100 Mount Street North Sydney

Project Approval MP08_0241

Environmental Assessment Report - Modification 4

December 2015

FIGURE 11 – LOWER GROUND FLOOR LEVEL AMENDMENTS

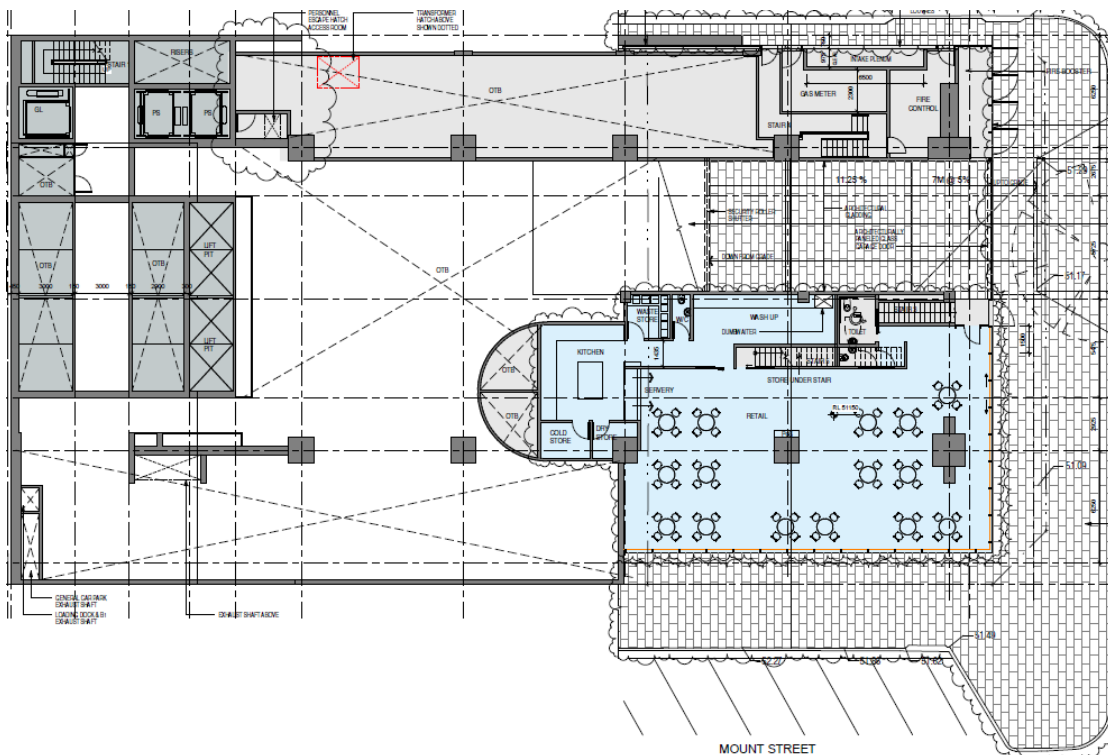
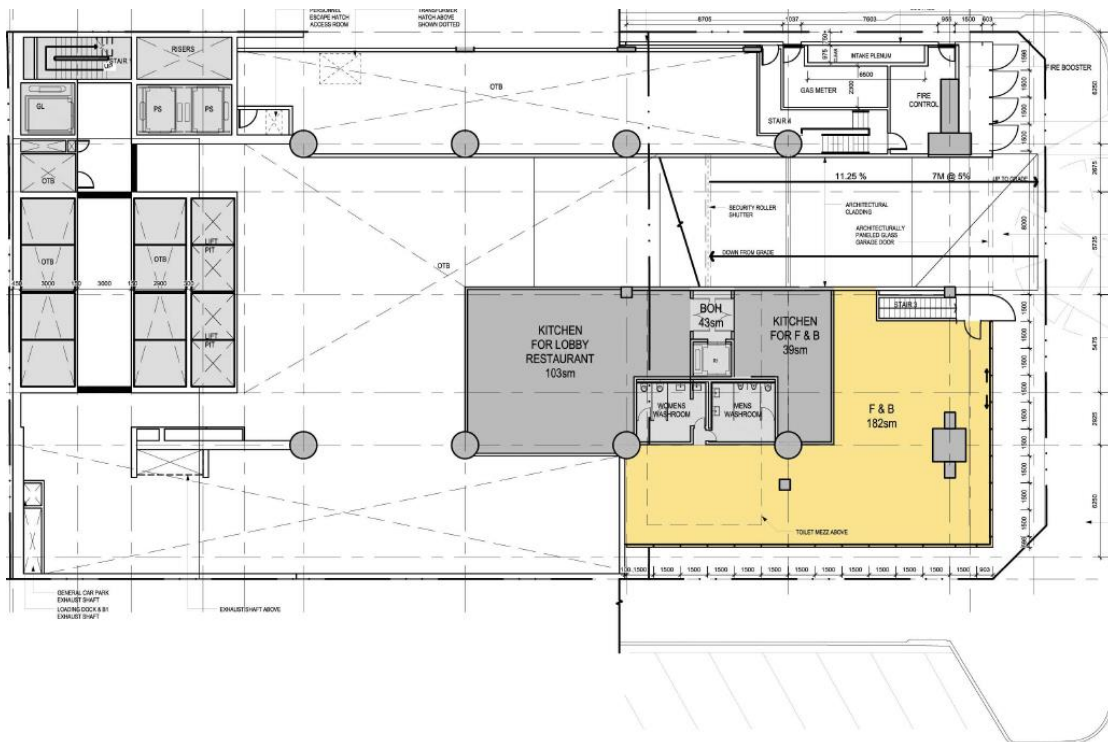
The lower ground floor level modifications include a reconfiguration of tenancy to accommodate a kitchen for the ground floor level restaurant. A new lift has been added to allow access from the kitchen to the ground floor level.

FIGURE 13 –GROUND FLOOR LEVEL AMENDMENTS

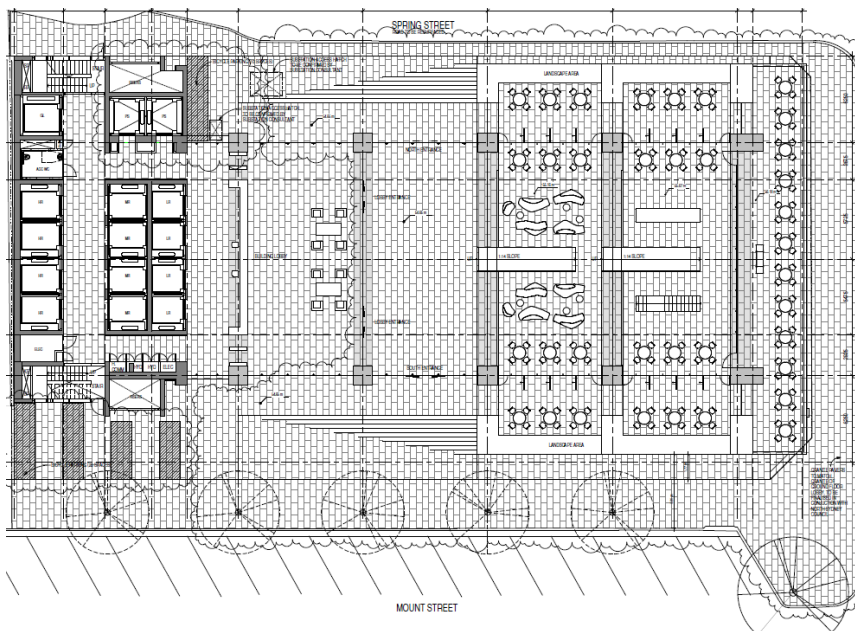
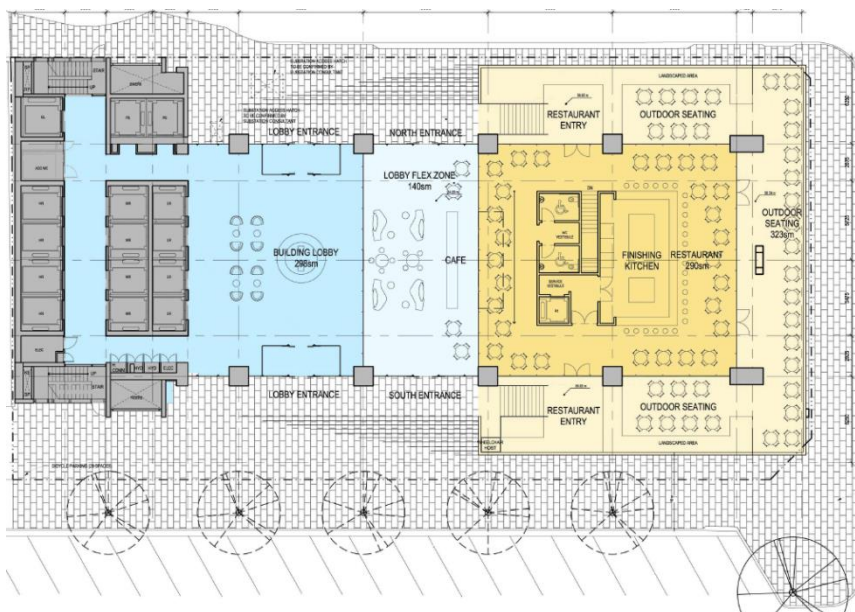
The ground floor level will be amended as follows:

- Deletion of ramps from lobby to café area.
- Creation of 140m² café in existing lobby area, and raised 290m² restaurant in the eastern portion of the building. The floor level of the restaurant will be two metres higher than the floor level of the lobby and café. Both the café and restaurant will be separated by internal walls, with access being from outside of the building.
- Addition of outdoor stairs on the northern and southern sides of the building to access the restaurant entries, as well as a wheelchair hoist on the southern side of the building.
- Relocation and reconfiguration of concierge desk to the centre of the building lobby.

FIGURE 14 –LEVEL 1 AMENDMENTS

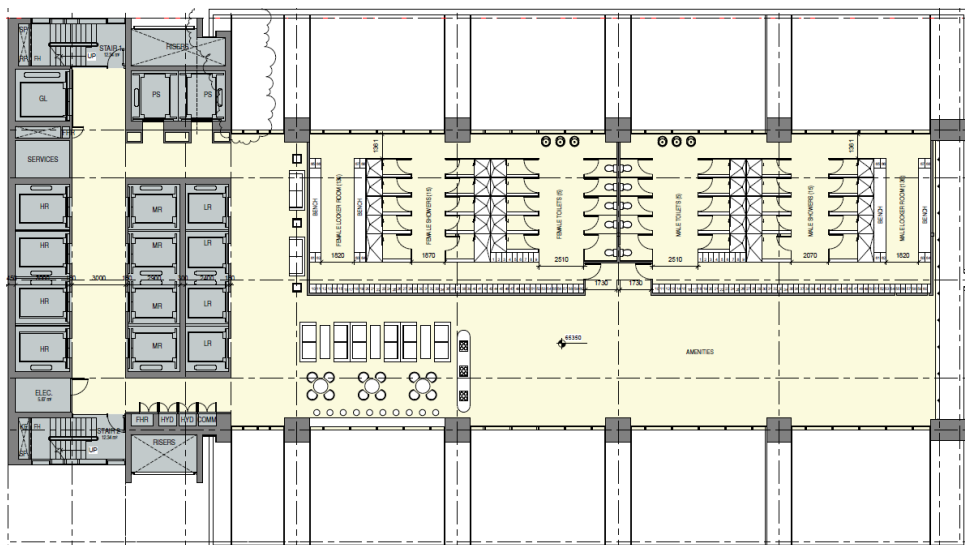
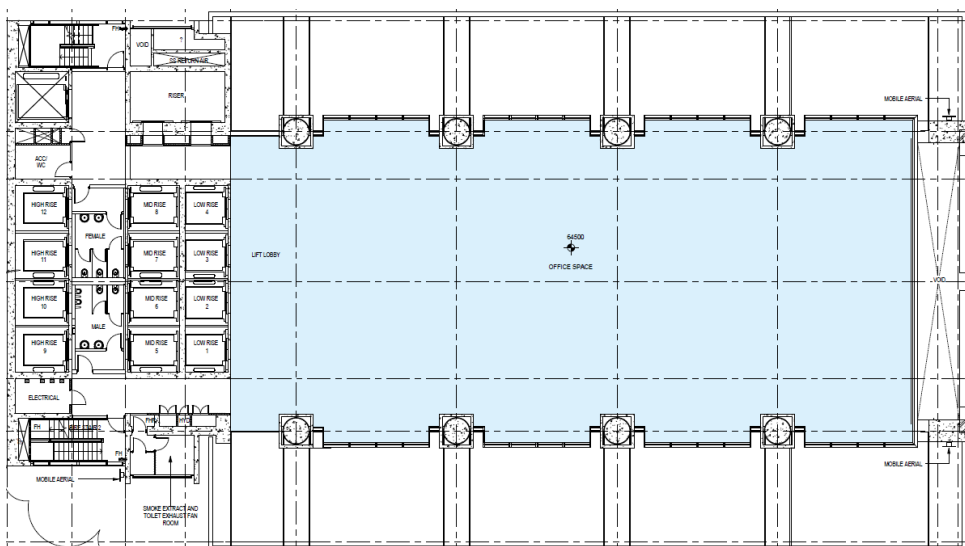
The end of trip facilities located on Level 1 of the approved development will be relocated to Basement Level 2 and replaced with office space. The floor area will be increased by 29m² which will not be perceivable from the streetscape.

FIGURE 16 – LEVEL 34 SECTION

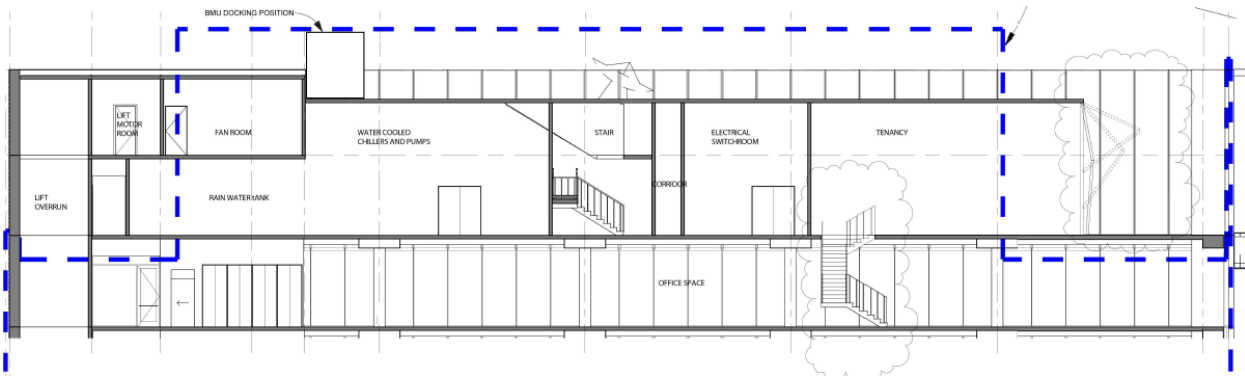
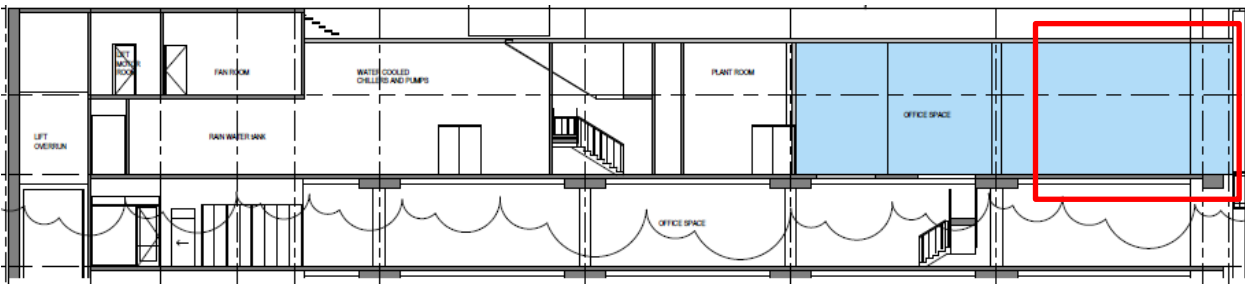
The proposed modifications to Level 34 include the reconfiguration of the existing office tenancy and enclosure of the existing outdoor area to create additional office space. The reconfigured tenancy would also include additional bathrooms. The extension of the tenancy on Level 34 would create an additional 404m² of floor area and would not be readily visible from the streetscape given the approved curtain wall extends above Level 34.
